## HEARING EXAMINER SITE PLAN REPORT

**REPORT DATE:** October 21, 2014

**Project Name:** My Dental Mixed-Use

**File Number:** LUA14-001148 ECF, LLA, MOD, MOD, SA-H

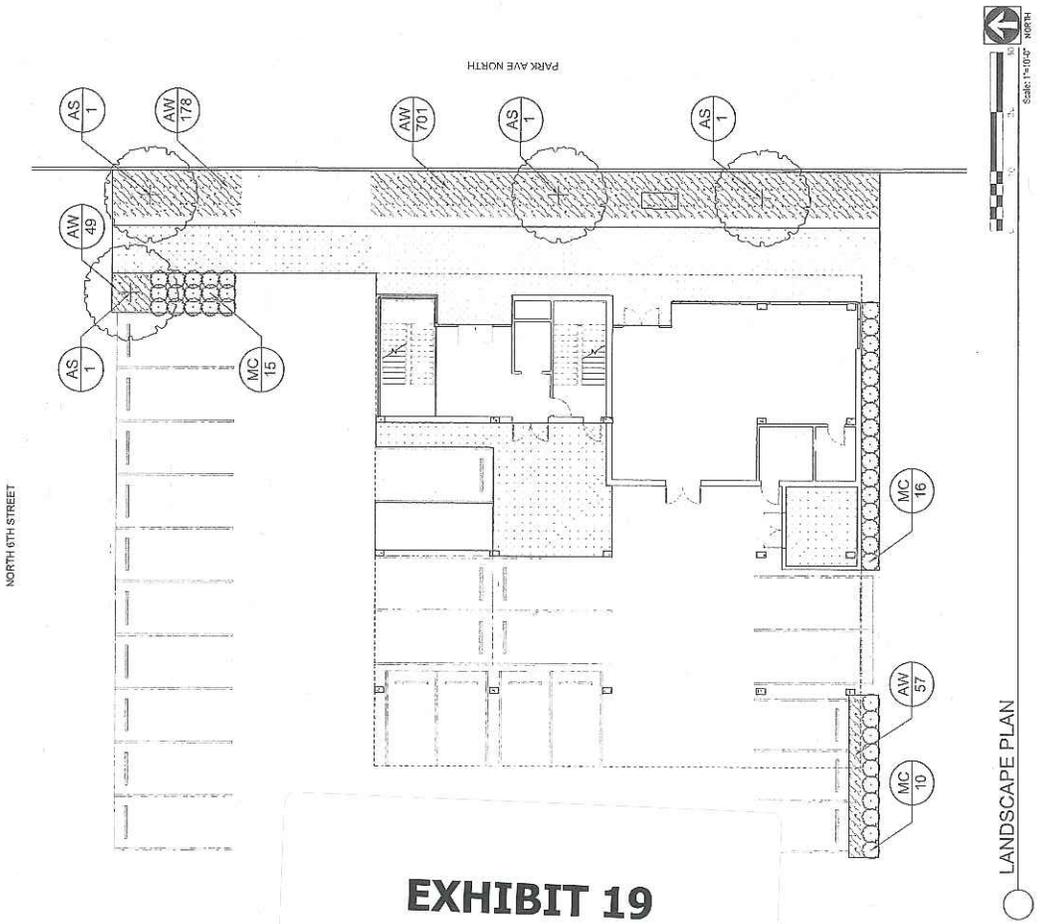
The applicant is proposing reduced landscape width of 6 feet 8 inches at the northeast corner of the site. The planting area would have a length of approximately 21 feet and be approximately 140 sf. The area would be planted with a tree, evergreen shrubs, and groundcover. Pursuant to RMC 4-9-250D, the applicant is requesting Administrative Modifications from RMC 4-4-070, Landscaping standards, to reduce the width of required landscaping along a street frontage and surface parking area along a street from 10-foot width to approximately 6 feet-8 inches width. The area of request has two landscape code requirements that apply to provide sufficient screening of vehicles from the public realm. RMC 4-4-070F.1 requires a 10-foot minimum landscape width on-site along a street and a 10-foot minimum landscape width between a surface parking area and street per RMC 4-4-070H.4.

Staff does not recommend the approval of a reduced landscape width at 6 feet 8 inches. Staff recommends a width of 8 feet as it is a similar width standard for public planter strip areas in the right-of-way. The applicant is encouraged to reduce the standard stall widths in the northern surface parking row to compact stall widths in order to accommodate the 8 feet of landscaping width. The stalls are numbers 1-10 as identified on Exhibit 15. Three standard stalls providing approximately 6 inches each would provide for an 8-foot wide landscape area.

3. The applicant shall be required to submit a revised landscape plan to the Current Planning Project Manager prior to building permit approval. The revised landscape plan shall depict the following: an 8-foot wide landscape area at the northeast corner of the site between the public right-of-way and parking stalls; a tree to be located in the landscape area at the southwest corner near the alley adjacent stalls 20-22 (Exhibit 15); a landscaped area to be created at the northwest corner near the alley where the parking stall number 10 (Exhibit 15) is reduced to a compact stall and a tree and groundcover planted; and updated shrub plantings that grow taller than the proposed Oregon grape in the proposed landscaped areas on the southern boundary.
